# SERVICE BULLETIN

INSPECTION OF AIR INTAKE BOX BY-PASS FLAP HINGE.

All T67M, M MKII and M200 Series Aircraft.

FIG. 1.

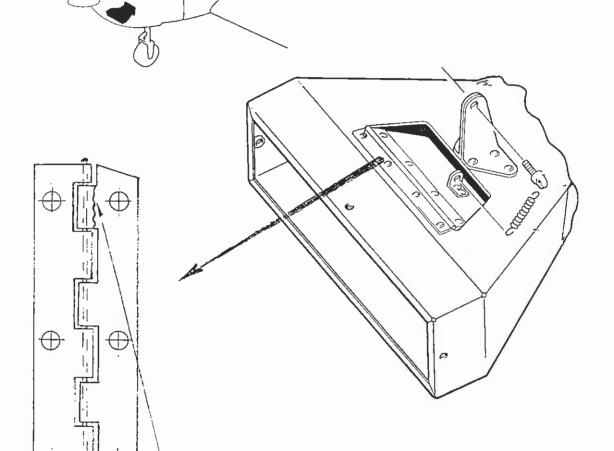
Inspect the Air Duct Assembly for signs of loose rivets and loose hinge pin. Particular attention should also be paid to each piano hinge segment as cracks can develop in the area shown in fig 1.

AREA OF POSSIBLE HINGE FAILURE

If three or more hinge segments are found to have cracked or loose hinge pins are found, the unit is not acceptable for continued service.

If one or two hinge segments are found to have cracked the aircraft can continue to fly subject to further inspections at subsequent 50 hour checks.

If no cracks or damage are found repeat this inspection at every subsequent 150 hour check.
